Rock-Ola Model 1442 Jukebox Amplifier Conversion

Conversion by Steve Luckey, 08/20/09

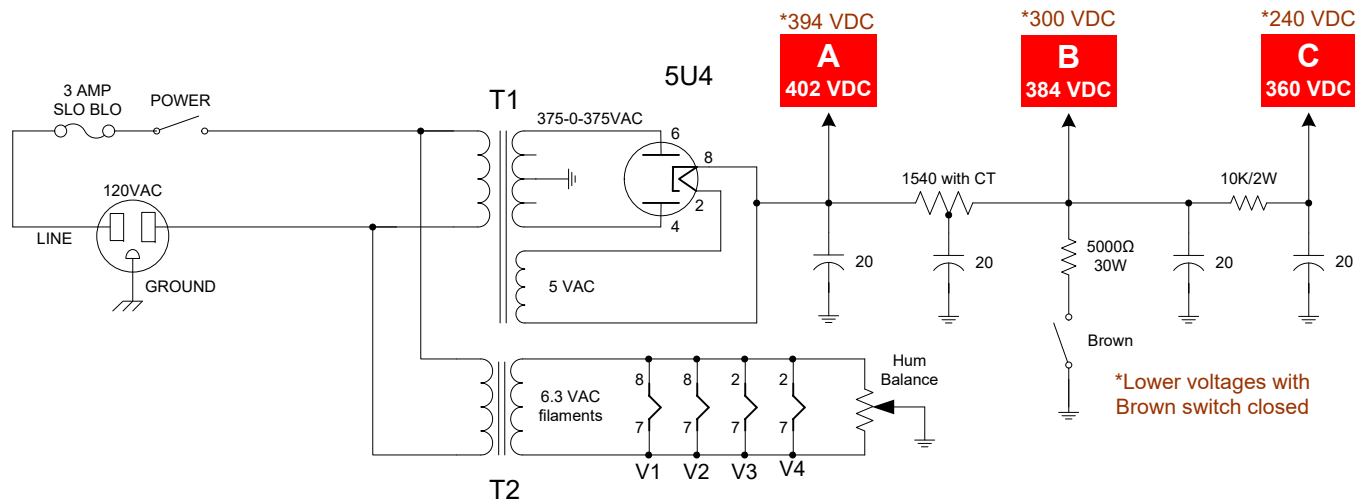
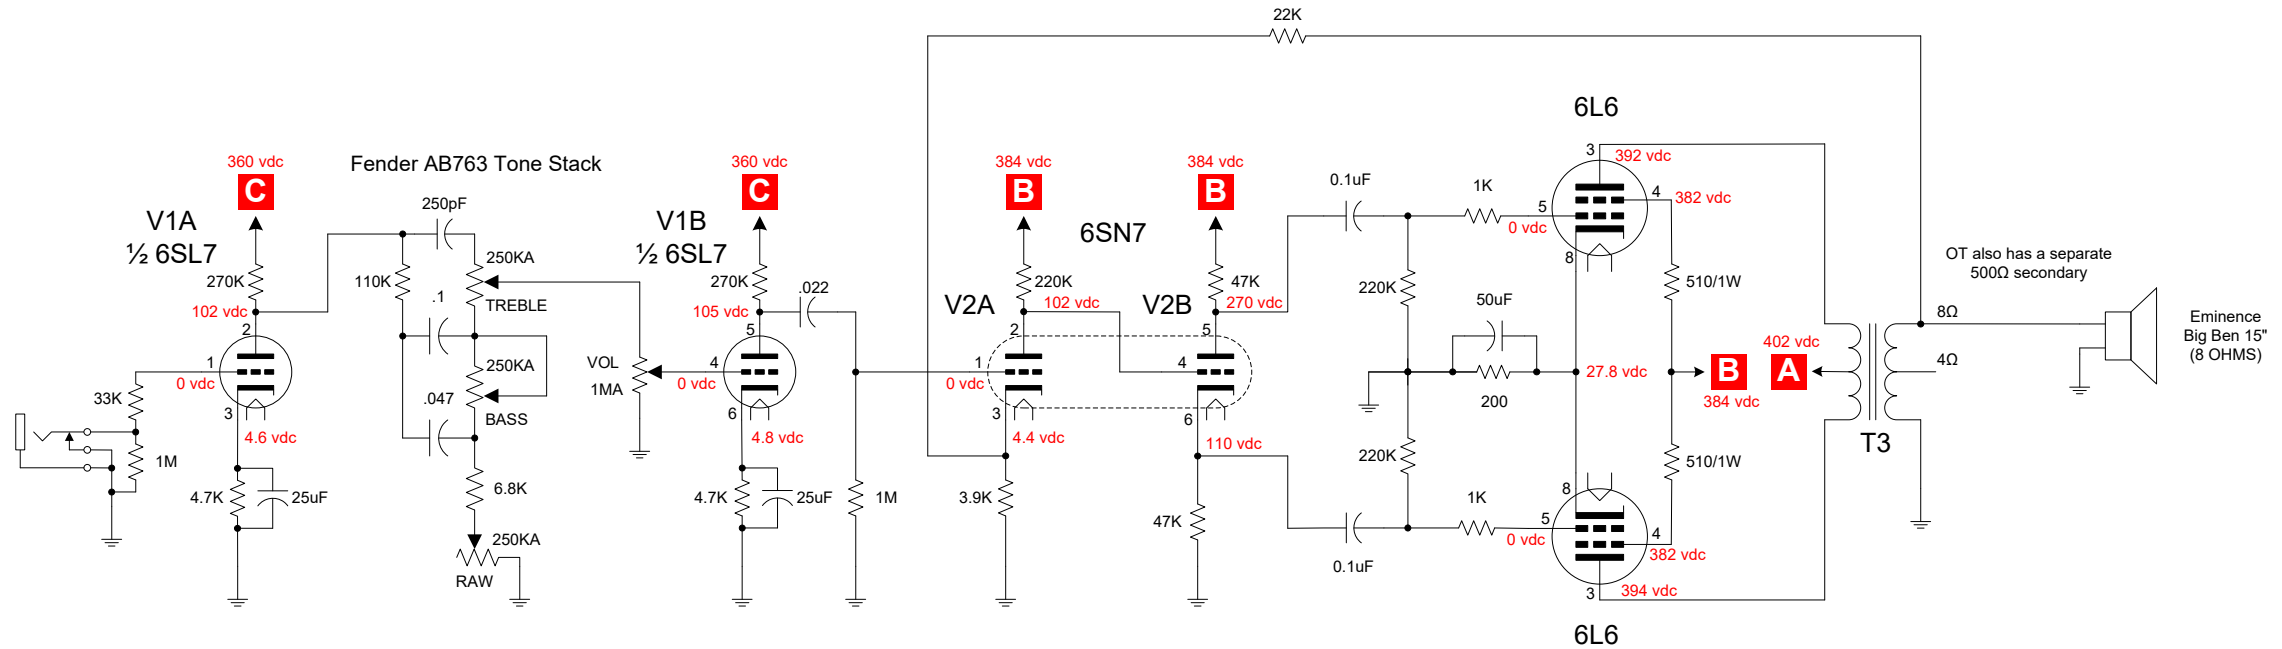
- ### Conversion notes
- Converted V1B cathode follower to a gain stage identical to V1A.
 - Replaced James tonestack with Fender AB763 tonestack plus Raw control.
 - Removed Hi cut filter at input to split phase inverter/driver.
 - Removed 75pF cap in NFB loop.
 - Replaced 100KΩ grid resistors for 6L6s with 220KΩ.
 - Installed 510Ω screen grid resistors.
 - Replaced field coil with 5KΩ 30W resistor and added Brown switch.
 - Replaced 6.8KΩ dropping resistor for Node C with 10KΩ 2W resistor.
 - Added onboard filament transformer T2.
